What is changing?

The Oil Furnace Heat Exchanger Clean-Outs will now be accessible through a tube that protrudes through the inner front of the furnace. The tube will have a gasket and cap secured by two screws.

BCL, BFL, BML, HML, HTL, WML, MPL

Clean-Out Tubes and Caps
through the Inner-Front

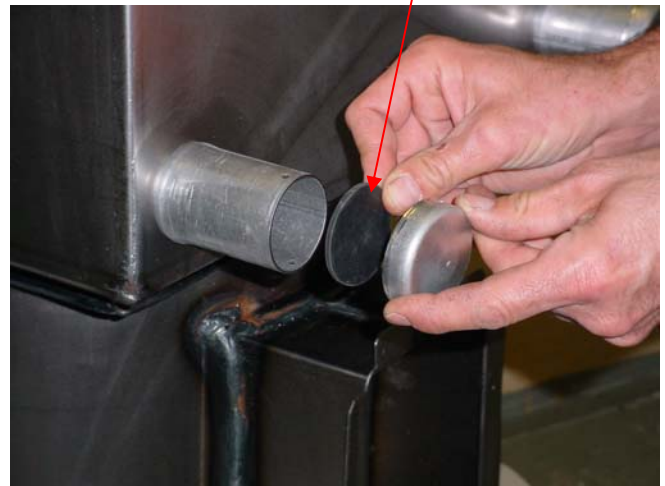
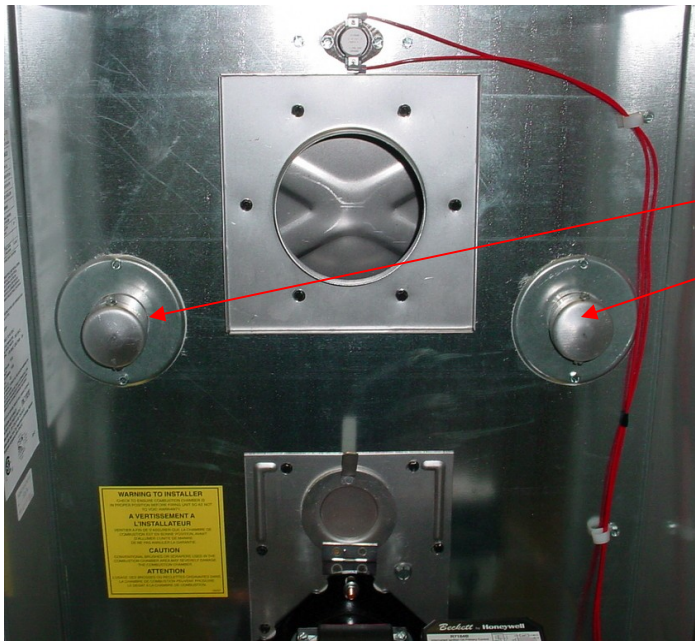
In response to numerous customer requests the new design will allow direct access to the heat exchanger from the inner-front. The new design will eliminate clean-out covers and tools falling between the inner-front and the heat exchanger.
